**Computational Analysis of
The Proposed Cooling Tower Installation
At Indian Point Units 2 & 3
FINAL REPORT**

Alden Report No:
413038-1R1

BREI Independent Review of the Proposed ClearSky© Cooling Towers Impact on the Indian
Point Energy Center Main Condensers

Prepared by Burns and Roe Enterprises, Inc.
Nuclear Services and Advanced Technologies
for Entergy Nuclear

Figure 2 Condenser Tubesheet Joint Closure (Reference 10)

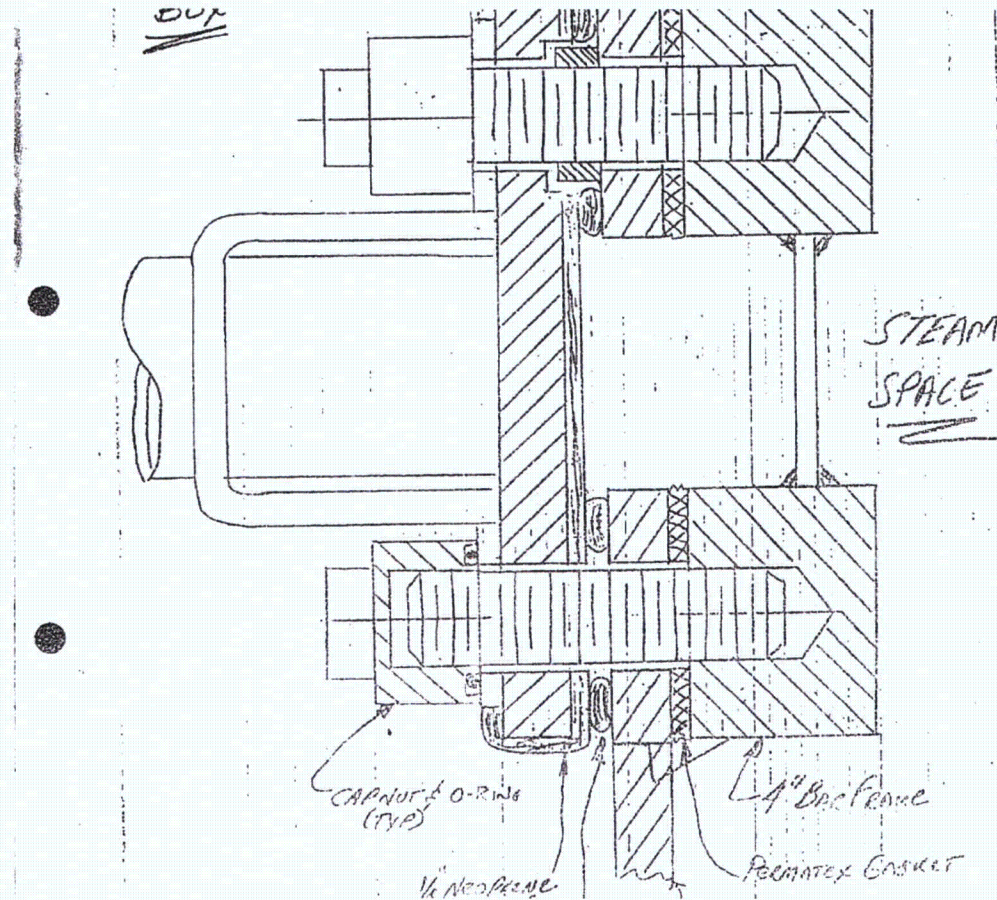
The documentation obtained from both Unit 2 and Unit 3 has not provided a sufficient level of detail regarding this joint closure. BREI has assumed that the tubesheet joint closure is similar for both units. BREI opines that if the existing closure “bridge bar” and associated components have been performing as intended in the current configuration, then the additional waterbox pressure resulting from the proposed ClearSky® closed-cycle cooling system should not degrade the performance, as the additional pressure should act to compress and seal the gasketed joints. Nevertheless, BREI recommends that if the ClearSky® closed-cycle cooling system is implemented, rechecking the torque especially when there is vacuum on the unit and no circulating water in the waterboxes is necessary.

Figure 3 Condenser Tube Bundles (Reference 7)

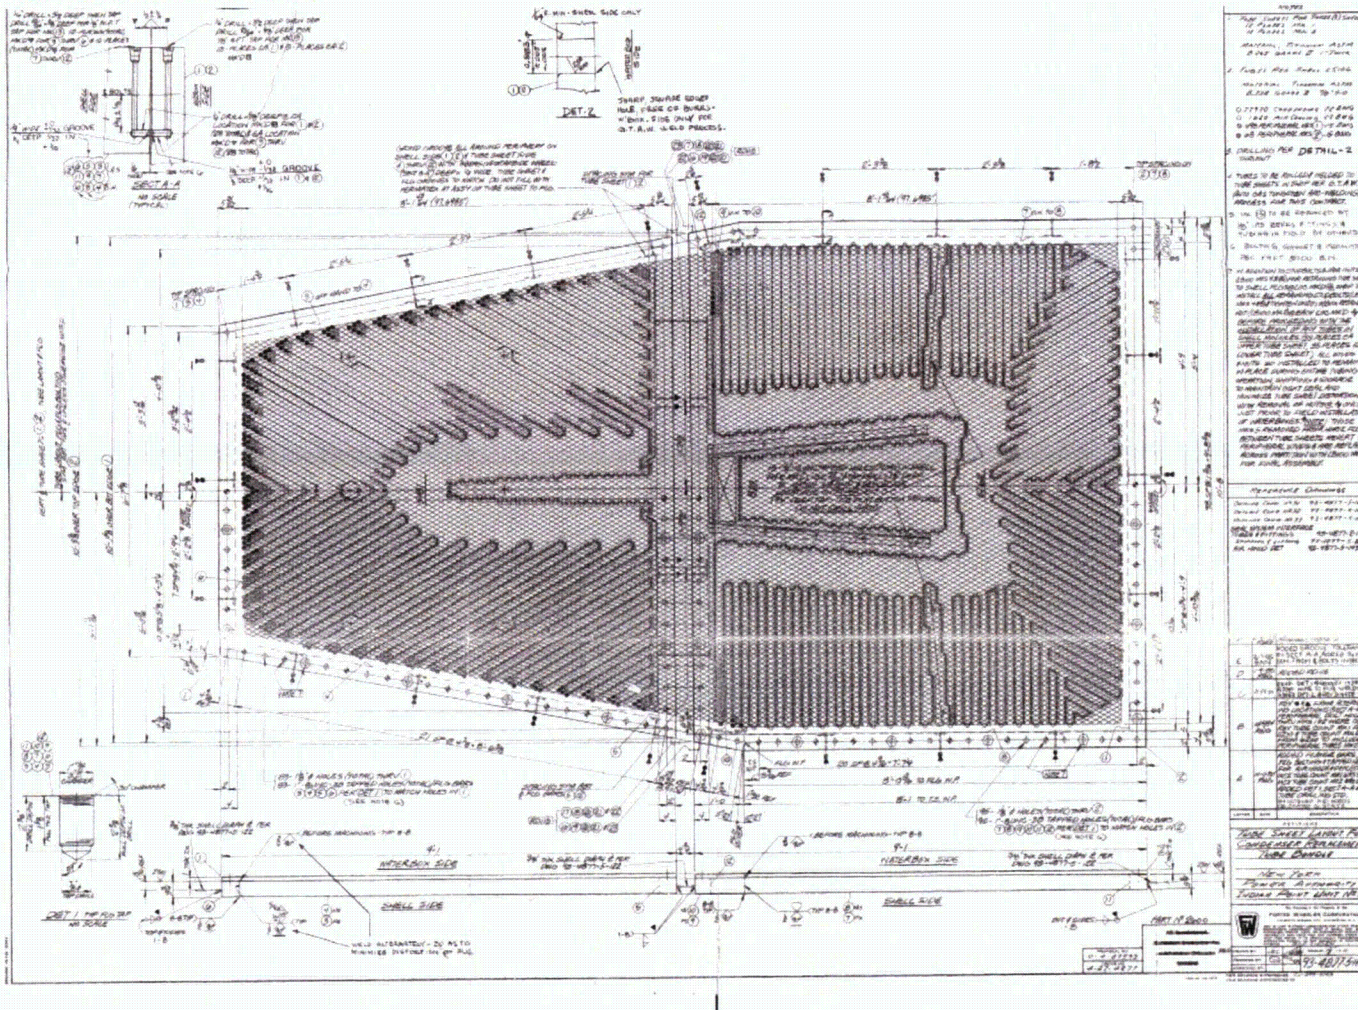
The condenser tube bundle flange and bolt configuration is depicted on Figure3 below.

Figure 1: Effect of Approach to Wet-Bulb Temperature on Cooling Tower Sizing

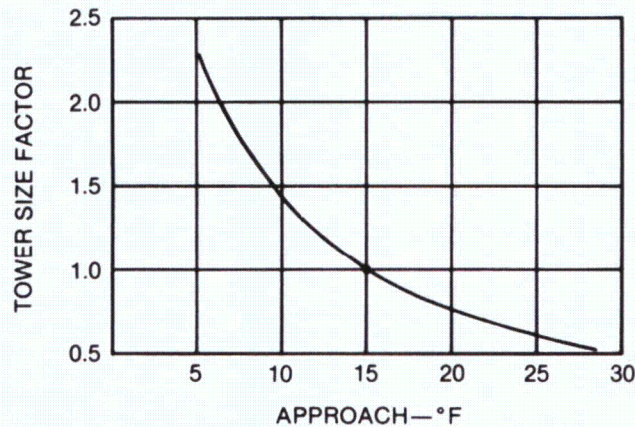
The cooling tower configuration selected by Riverkeeper utilizes a significantly higher approach to wet-bulb temperature than does Tetra Tech. The approach to wet-bulb temperature is used to determine the temperature the cooling tower is capable of cooling the condenser inlet water temperature to at the design wet-bulb temperature. For example, the Riverkeeper selected cooling tower configuration would be capable of cooling the closed-cycle cooling water to 93°F (17°F + 76°F) when the ambient wet-bulb temperature at the cooling towers is 76°F. Increasing the approach to wet-bulb temperature decreases the cooling tower size, but results in greater circulating water temperatures. The figure below provides a graphical representation of how cooling tower size is affected by the approach to wet-bulb temperature selected, assuming a fixed heat load, flow rate, and design wet-bulb temperature.

The increased circulating water temperature and reduced flow rate specified by Riverkeeper's cooling tower configuration impacts Indian Point's ability to generate electricity, may result in Unit down-powering during times in excess of the condenser operational limits, and does not take into account transient or accident analysis. The balance of plant systems at each Unit relies on the condenser's ability to remove the design heat load from the system. Increasing the circulating water temperature decreases the condenser vacuum, resulting in reduced power generation at the turbines. Similarly, decreasing the circulating water flow rate from the current design of 840,000 gpm to 600,000 gpm (or a decrease of approximately 29%) results in further power reduction.
